Name of Proposed Subdivision HARRIS HEIGHTS ADDITION PHASE TWO

FACT SHEET

Re: Harris Heights Addition
Phase II

Re: Harris Heights Phases I, II, III,
and IV - Revised Plat

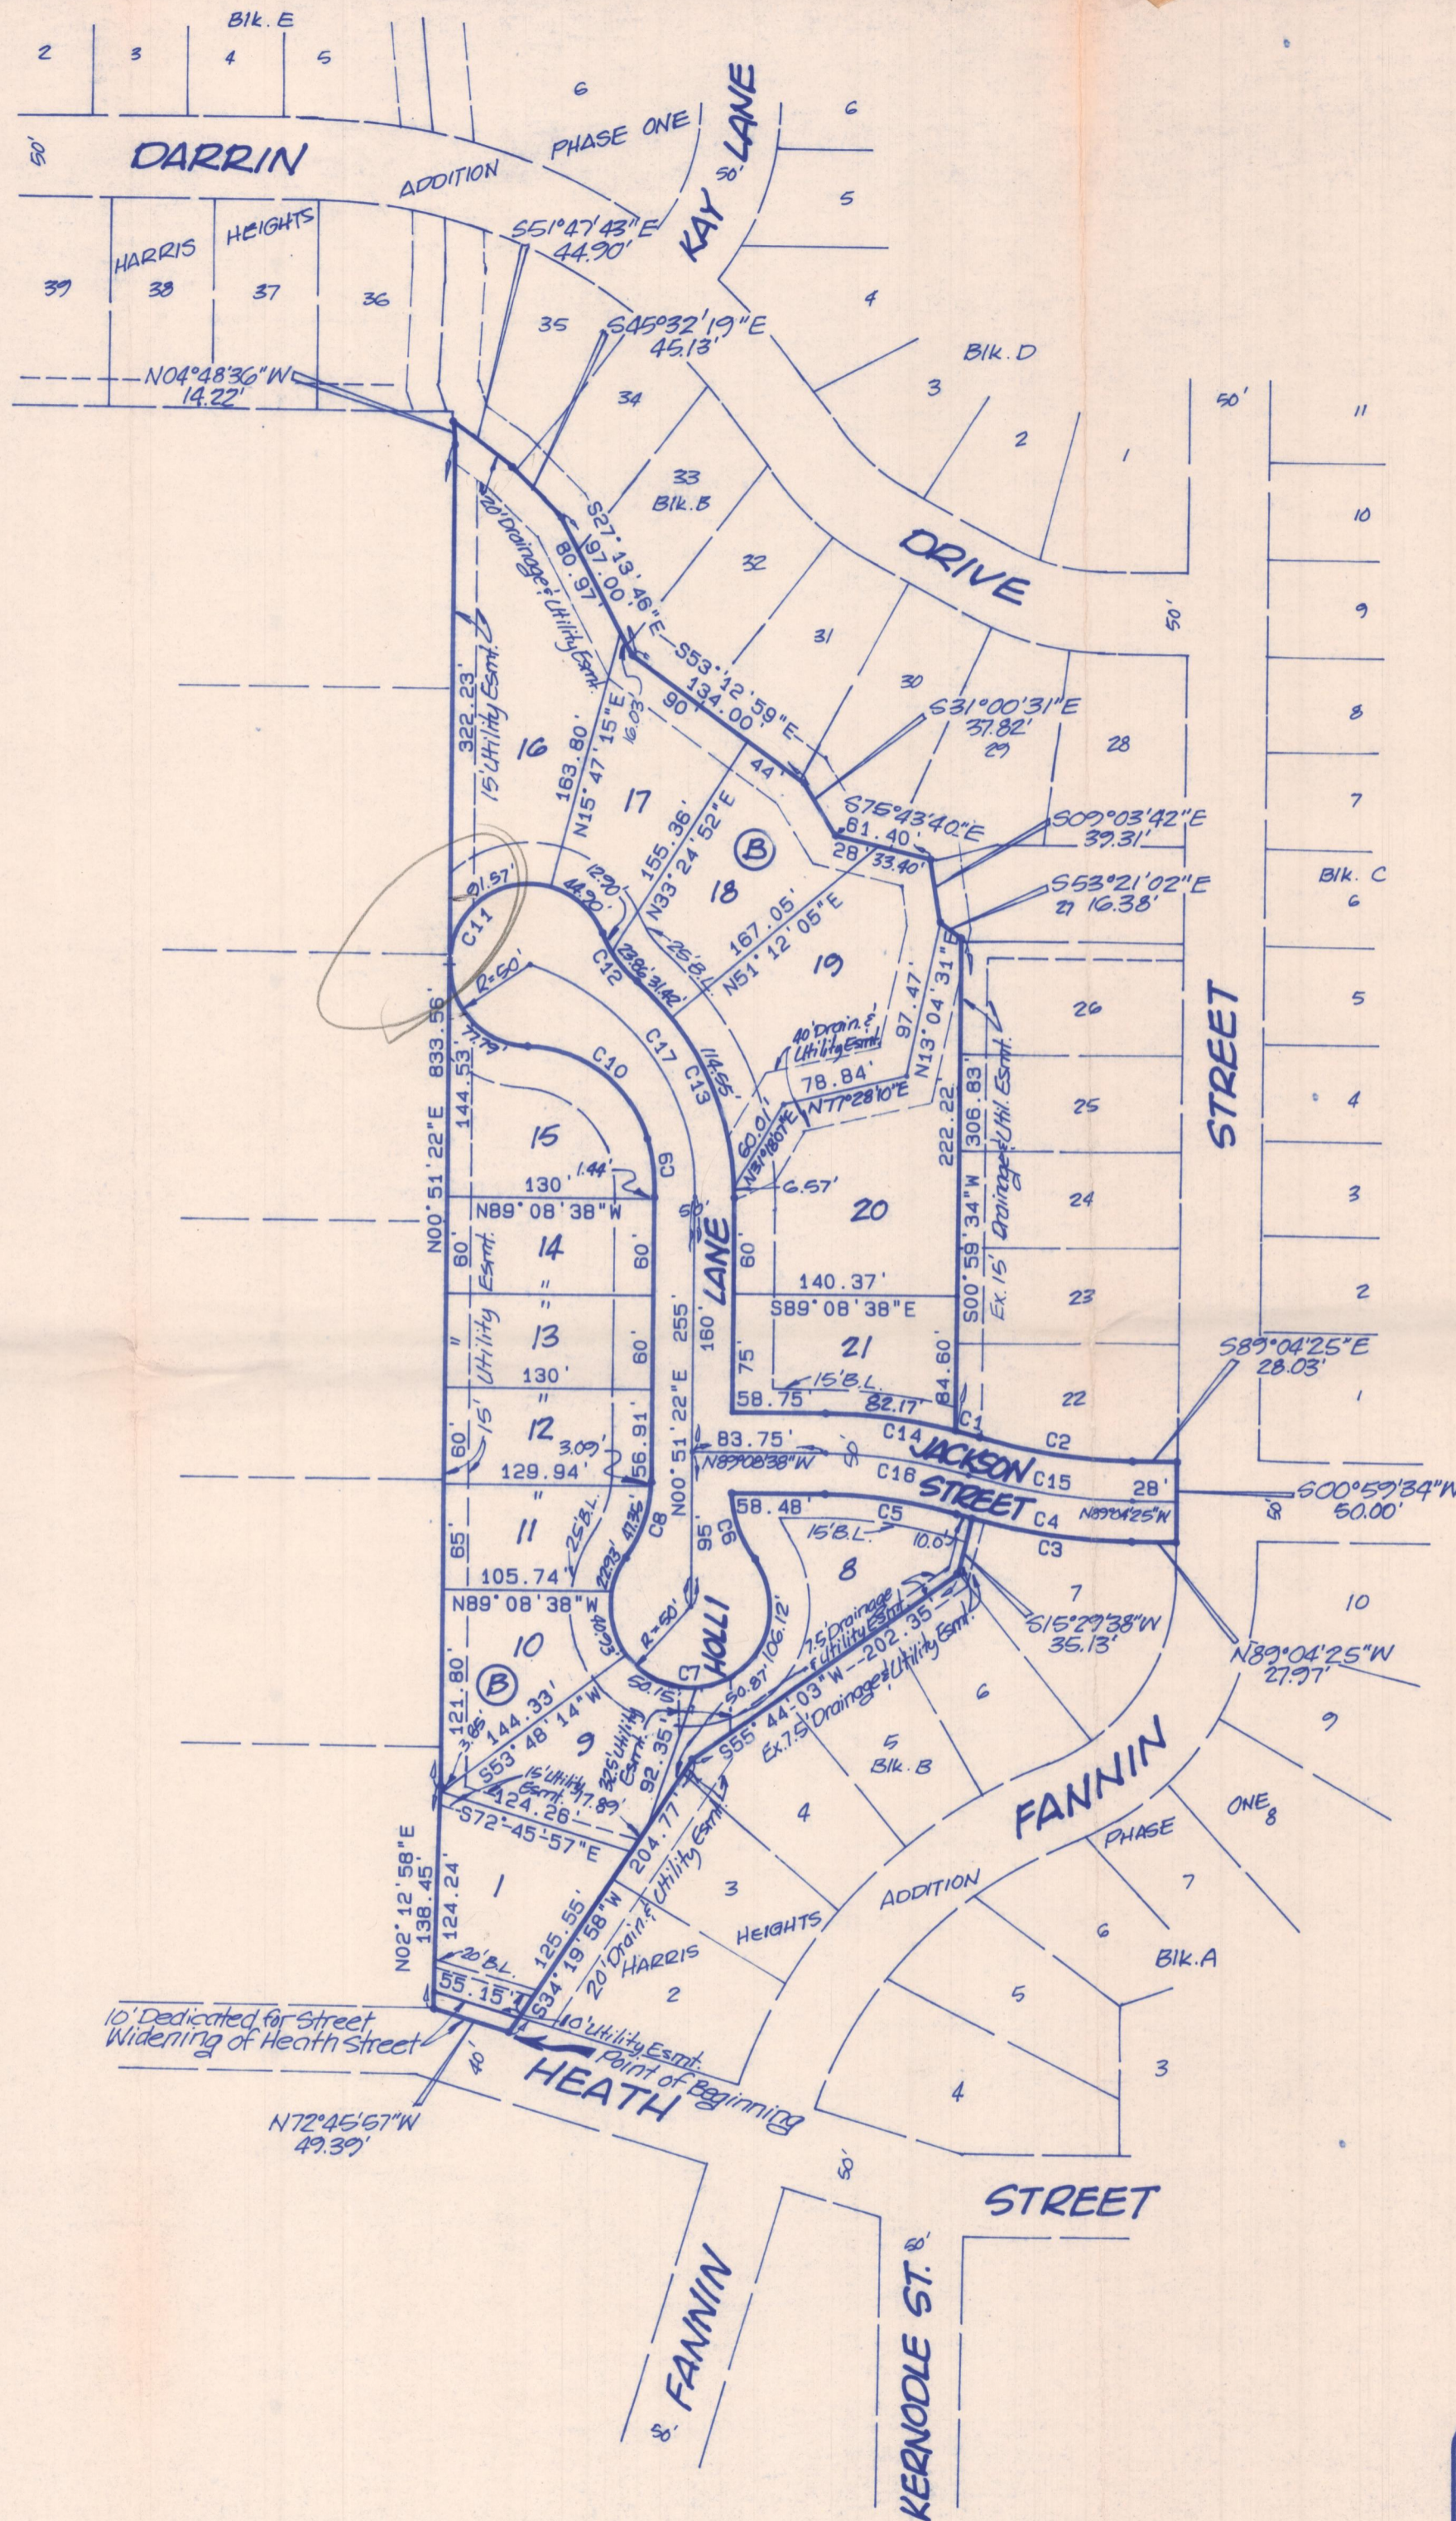
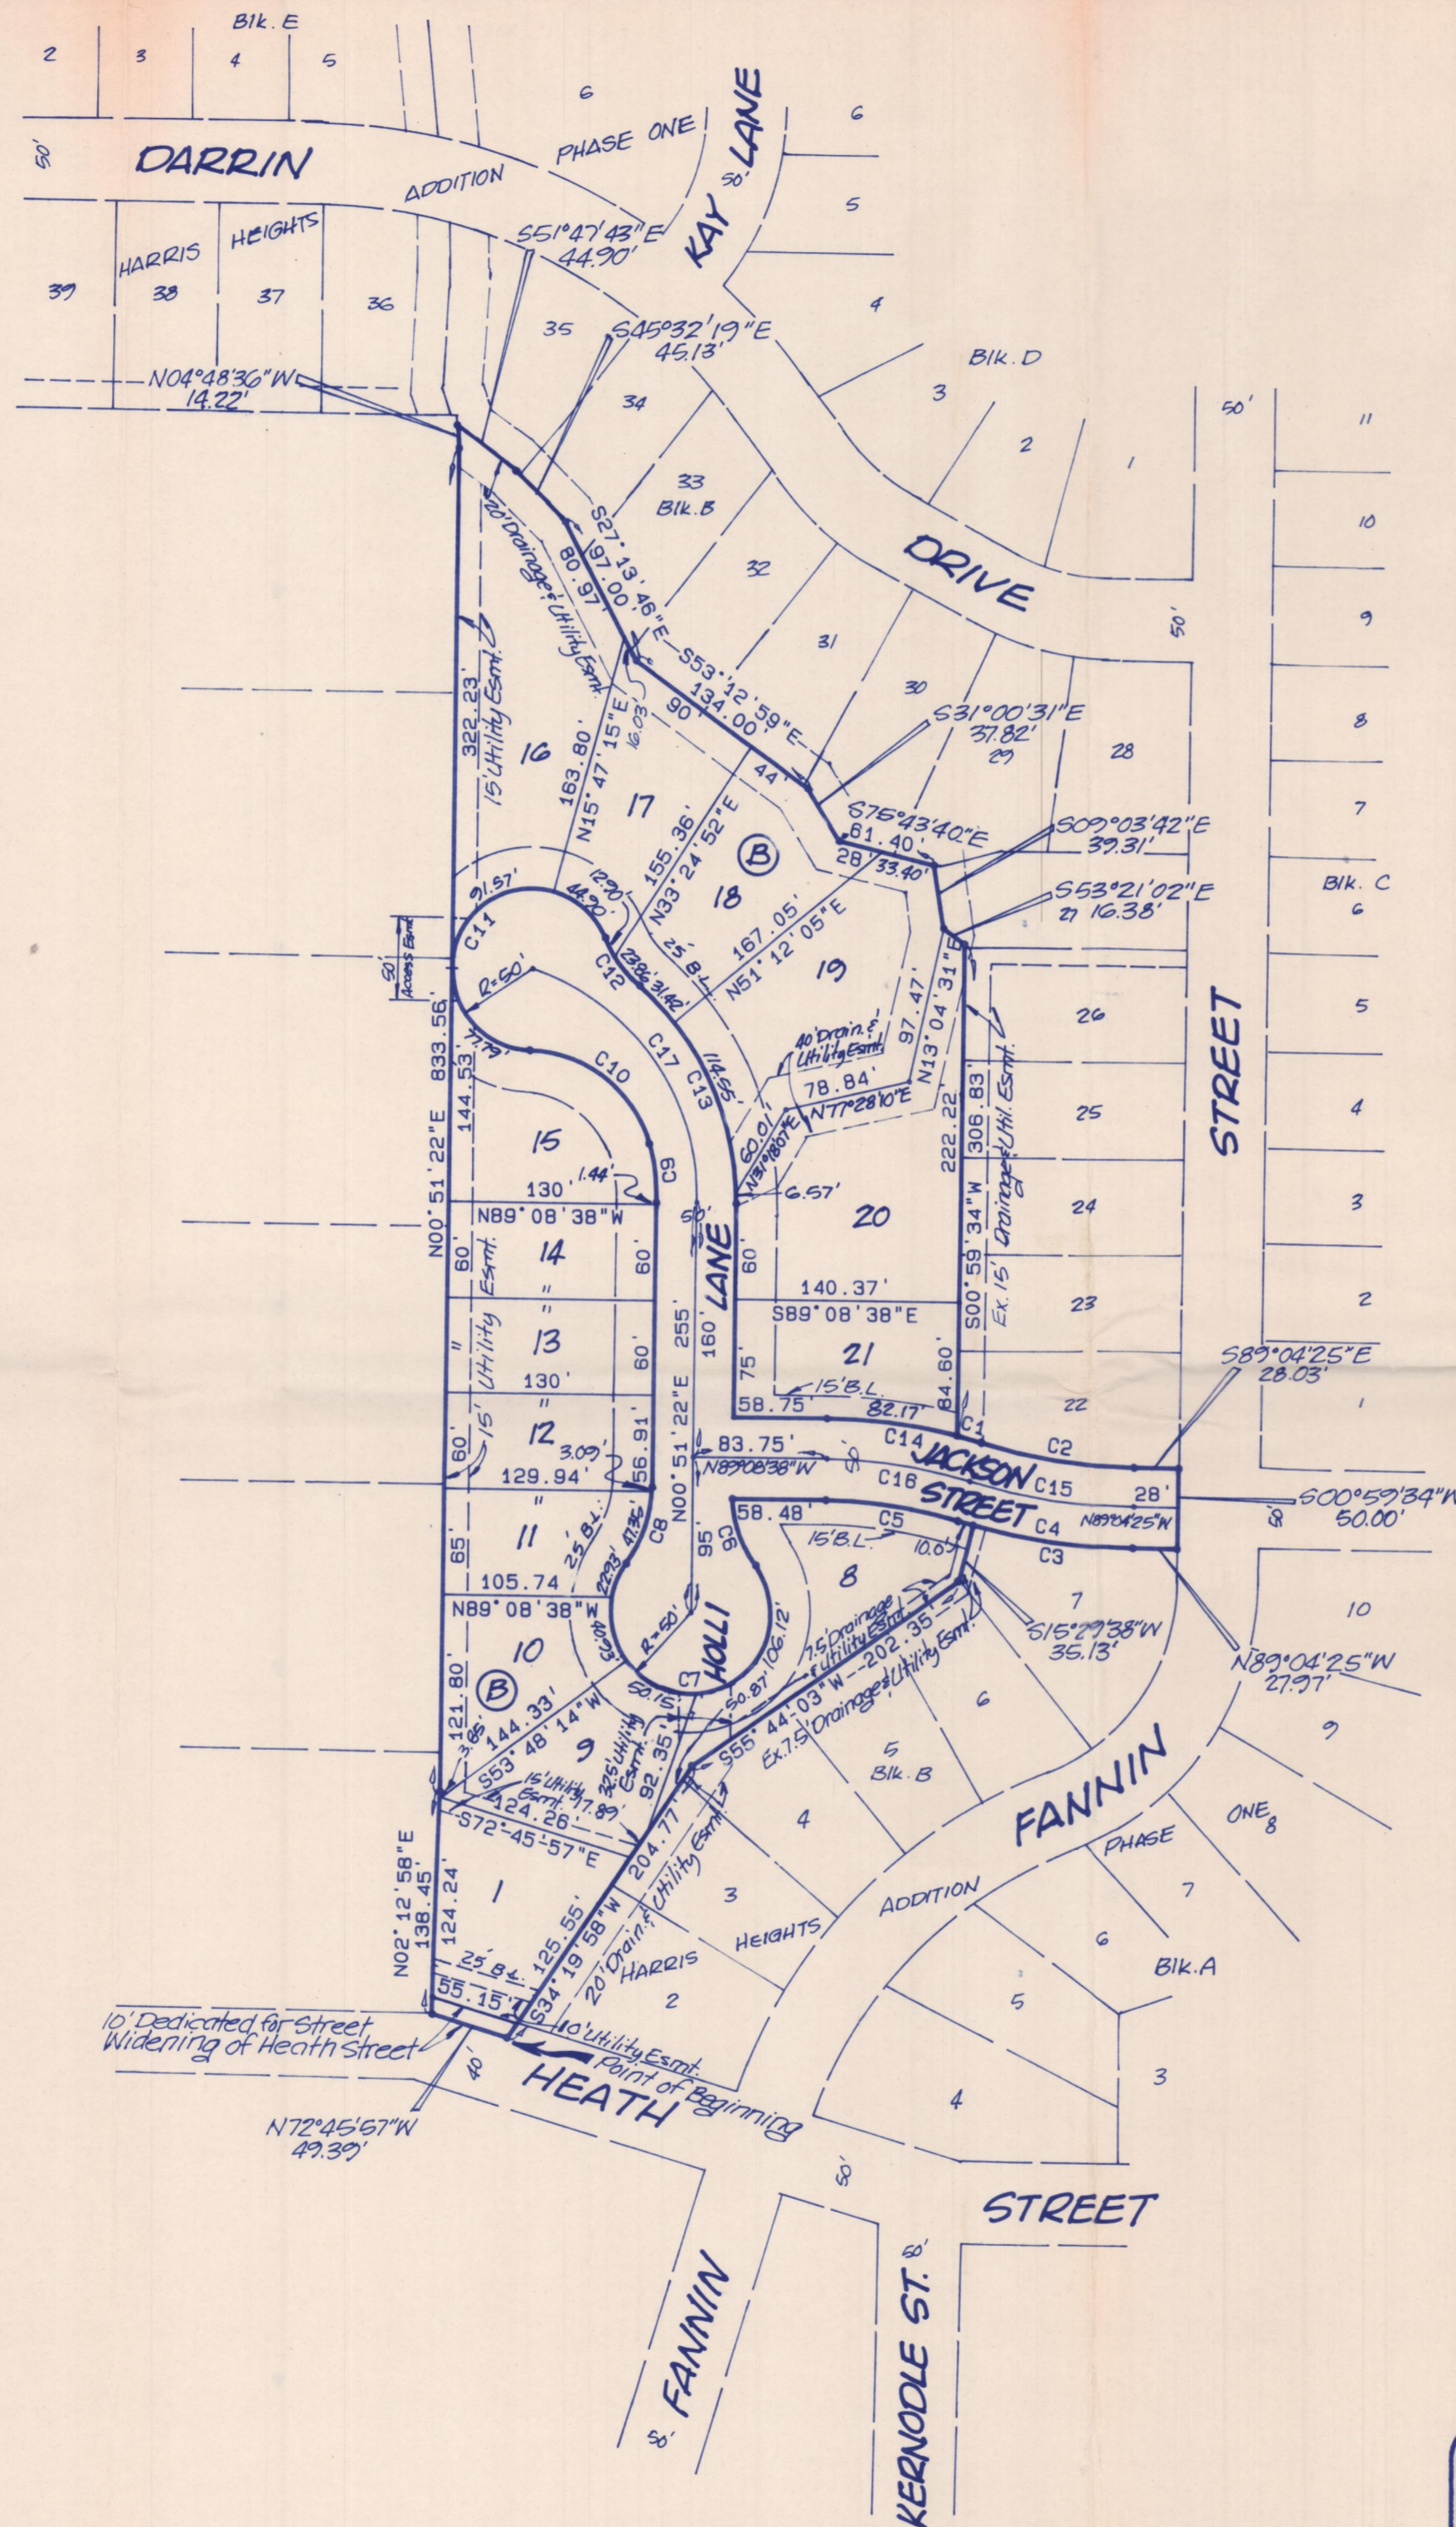
Staff Comments: Since Holli Lane will eventually tie into adjoining property, we would suggest clipping off the curves at the property boundary to make an easier connection. Field notes have errors in curves 1 and 2. Engineering must be resubmitted to Freese and Nichols.

4/12/84 - Approved with 25 ft. building line, corrected curve data, dedication for extension of Holli, and engineering approval.
